**SUBDIVISION, PLANNED UNIT DEVELOPMENT, &
PLANNING APPROVAL STAFF REPORT**

Date: November 2, 2006

Ashland Place United Methodist Church

Ashland Place United Methodist Church Subdivision

SITE PLAN

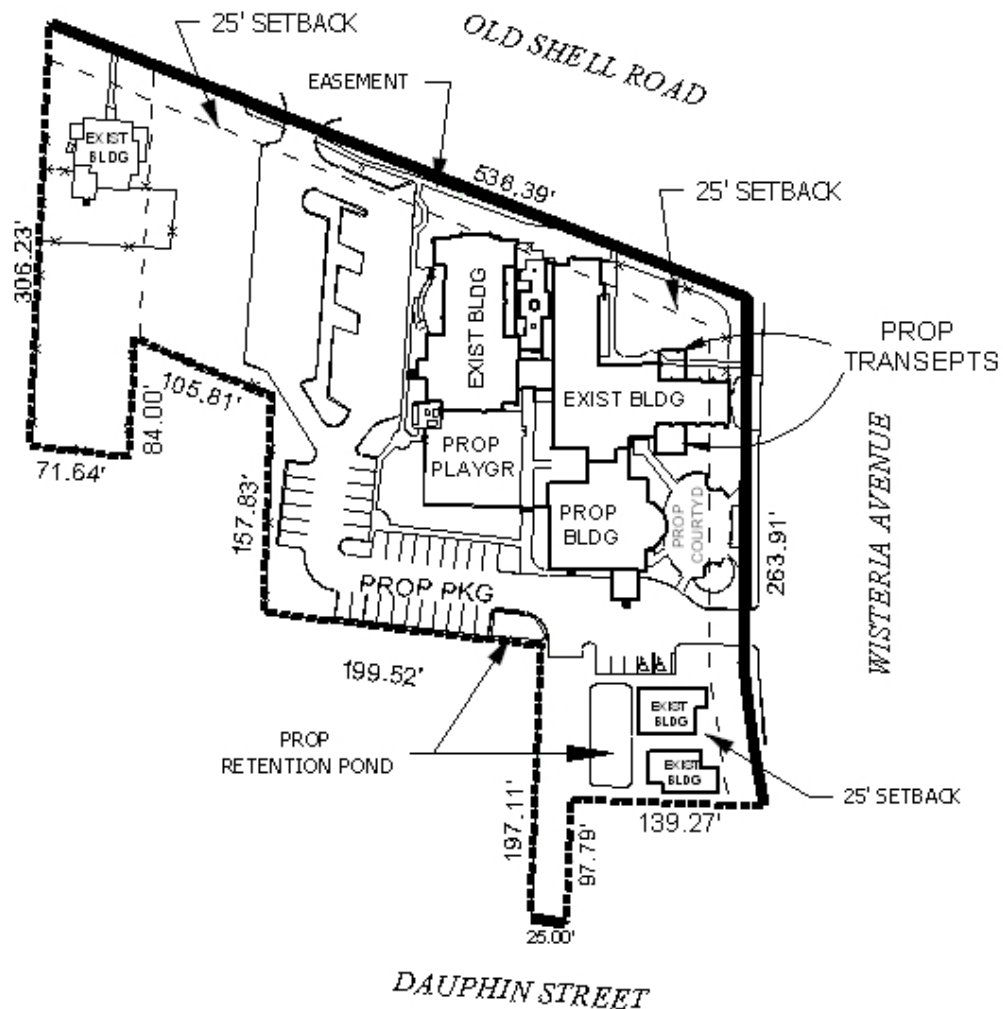
The applicant is requesting PUD approval to allow multiple buildings on a single building site. The property is already developed with multiple buildings on the site, and several additions are proposed to one of these, the sanctuary. In the place of an existing parking lot fronting Wisteria Avenue, an administration and choir building and courtyard are proposed. In addition, two new transepts are proposed for the sanctuary, which the applicant's architect estimates would increase capacity from around 200 currently to around 300. This would increase the need for parking from approximately 50 spaces to approximately 75 spaces.

The site has approximately 50 spaces that would remain on the Western portion of the site. Forty-one new parking spaces are proposed on the on the Southwest corner where there is currently a rectory South frontage of Wisteria Avenue; and an "optional parking" area is shown on what is currently three residential lots, two of which still have houses. This optional parking area need not be built to meet zoning requirements, based on the information provided. If built, it would need to be screened in compliance with Section VI.A.3.i of the Zoning Ordinance.

The site plan does not illustrate a parcel that is shown on the subdivision plat, a metes and bounds parcel containing a single family home to the West of the site; the applicant's architect states this is currently used for administrative purposes, but would not be needed as such following construction of the administrative building. This site should either be brought into the present PUD and Planning

Regarding circulation on the site, most aspects would meet the requirements of the Zoning Ordinance. However, the site has a 25-foot access to Dauphin Street, which could not accommodate two-way traffic. Neighboring property owners have stated that this is a desirable alternative to Wisteria Avenue for access, but the parking area must be signed and marked to restrict it to one-way traffic.

While the nature of the proposed building improvements would appear harmonious with the surrounding development, there are some concerns about replacement of viable single-family homes with parking for the church. As Wisteria Avenue is a small street, each house weighs heavily in the balance of its residential character. There are currently only five homes on the East side of Wisteria Avenue, and the last two of their complements on the West side of Wisteria Avenue are proposed for demolition. That this would occur to provide parking that is not even required by the Zoning Ordinance makes it inadvisable. There is undeveloped land to the West of the existing parking area facing Old Shell Road, the development of which would have less of an impact on residences across Old Shell Road, because they face the side streets rather than the church property. It is worth noting that the interior of the block bounded by Old Shell Road, Wisteria Avenue, Dauphin Street, and Homer Street has an abundance of undeveloped property that might be acquired and subdivided to provide the church with future parking that would not undermine the residential character of the neighborhood. Prior to demolishing existing residential structures, the church should demonstrate that more “harmonious” options for parking development have been exhausted.

Due to these concerns, it is recommended that the site plan and subdivision be revised to incorporate all areas to be redeveloped, and ideally to eliminate the residential sites on Wisteria Avenue from the site plan and subdivision plat.

The applicant has submitted revised plans that illustrate the entire site, as well as proposed improvements (removal of an existing residential structure located near the South property line of the site, additional and reconfigured parking facilities, as well as a reworked access to Wisteria Avenue). The revised plans also reflect the two single-family dwellings on Wisteria as remaining, which was a major concern with the original submission.

The primary concern with the master plan is that it still proposes demolition of the only two remaining residential structures on the West side of Wisteria Avenue. While that phase of the plan is 10 years away, the toll that the loss of those residences would take on the remaining residences on the East side of Wisteria Avenue would probably be the same.

The narrative states that the intent is to create a pedestrian friendly campus that preserves the character of the campus and the neighborhood. It would seem that relocation of the proposed Fellowship Hall to the area behind the existing Fellowship Hall would be more pedestrian oriented (closer to all other buildings and major parking facility), and would allow the residential structures along Wisteria Avenue to remain, thus maintain the character of the neighborhood.

Recommendations: **Subdivision.** *Based on the preceding, it is recommended that the plat be granted Tentative Approval subject to the following conditions: 1) placement of a note on the final plat stating that the site is limited to one curb cut to Old Shell Road, Wisteria Avenue, and Dauphin Street, size location and design to conform to AASHTO standards and to be approved by the Traffic Engineering Department; 2) provision of a buffer in compliance with Section V.A.7. of the Subdivision Regulations.*

Planning Approval. *Based on the preceding, it is recommended that the master plan be approved in concept, with consideration given to relocation of the proposed Fellowship Hall so the residences located along Wisteria Avenue can be retained. It is also recommended that Phase I, removal of 1 residential structure resulting in the addition of +/- 40 new parking spaces, reworking of vehicular access from Wisteria Avenue and the relocation of the existing playground, be approved as proposed; it is further recommended that an individual application for Planning Approval be required each subsequent phase or project.*

Planned Unit Development. *Based on the preceding, it is recommended that the master plan be approved in concept, with consideration given to relocation of the proposed Fellowship Hall so the residences located along Wisteria Avenue can be retained. It is also recommended that Phase I, removal of 1 residential structure resulting in the addition of +/- 40 new parking spaces, reworking of vehicular access from Wisteria Avenue and the relocation of the existing playground, be approved as proposed; it is further recommended that an individual application for Planned Unit Development be required each subsequent phase or project.*
